SPRINGHILL PLACE SUBDIVISION

APPLICATION NUMBER 23 DATE August 18, 2005

REQUEST Subdivision

DETAIL SITE PLAN

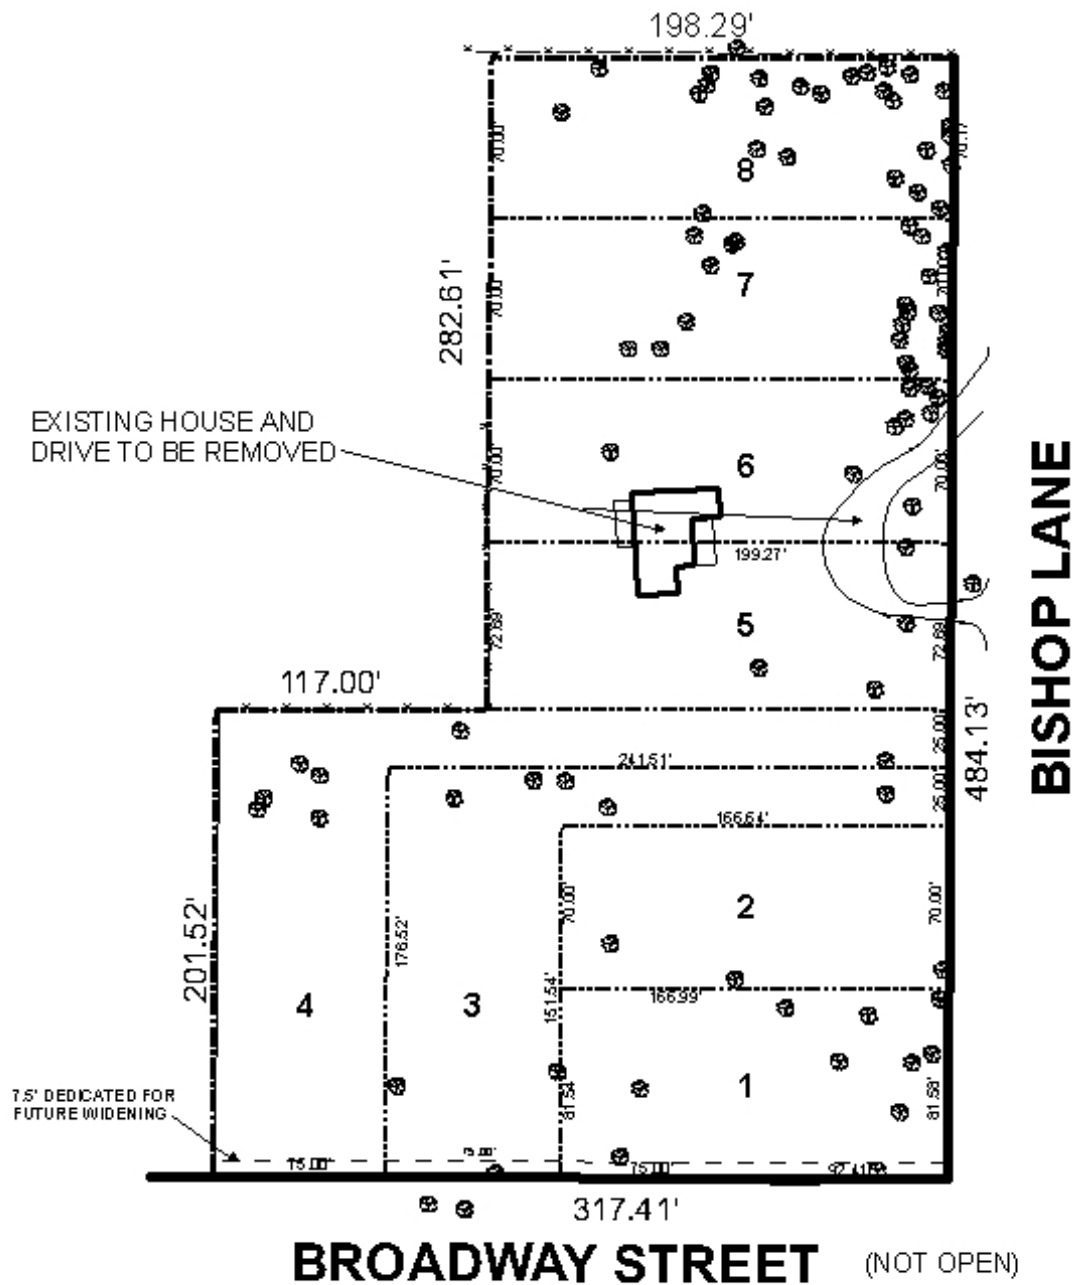
Engineering Comments: Stormwater detention and Common Area for such not shown on preliminary plat. Stormwater detention is required for this site and must be constructed within a Common Area prior to approval of the final plat. Must comply with all stormwater and flood control ordinances. Any work performed in the right of way will require a right of way permit.

The site fronts Bishop Lane, which has a 50-foot right-of-way, and an unopened right-of-way for Broadway Street, which ranges from approximately 35 to 40 feet in width adjacent to the site. The plat illustrates dedication of 7.5 feet for future construction of Broadway Street. The plat does not show the 25-foot building setback lines, which would be required on the final plat.

Proposed Lots 3 and 4 are shown as flag-shaped lots. Section V.D.1. of the Subdivision Regulations, states: "*The size, width, depth, shape, and orientation of lots and the minimum building setbacks lines shall be appropriate to the location of the subdivision and the type of development and use contemplated.*" It is not clear that such lots would be appropriate for this location; while there is a large parcel to the West of the site that is flag-shaped, such lots are uncharacteristic of the area in general. It should be noted that approval of this request could encourage future requests for subdivisions with flag-shaped lots.

The orientation of the houses on proposed Lots 3 and 4 poses further concerns, as they would essentially be double-frontage lots. Double-frontage lots are generally prohibited by Section V.D.8, except "*where necessary to provide separation of residential development from major streets or to overcome specific disadvantages of topography and orientation.*" Furthermore, the plat poses issues of orientation, which Section V.D.1 of the Subdivision Regulations (cited in the previous paragraph) also addresses. For the house to be oriented toward an unopened right-of-way would be undesirable; yet, in the event of Broadway Street's construction, for the rear of the

house to be exposed to an open street would also be inappropriate. The final option, where the houses would face the rear of other houses, would also be uncharacteristic and inappropriate for the area.

The plat contains a note indicating that the existing house and asphalt drive on the site are to be removed; this would need to be accomplished and verified prior to signing the final plat.

As noted by Engineering, detention is required but not shown on the plat; detention must be provided in a common area, to comply with all stormwater and flood control ordinances, and to be maintained by the property owners.

Based on the preceding, this application is recommended for Holdover to allow the applicant to redesign the plat without flag-shaped lots and with detention and common areas shown.
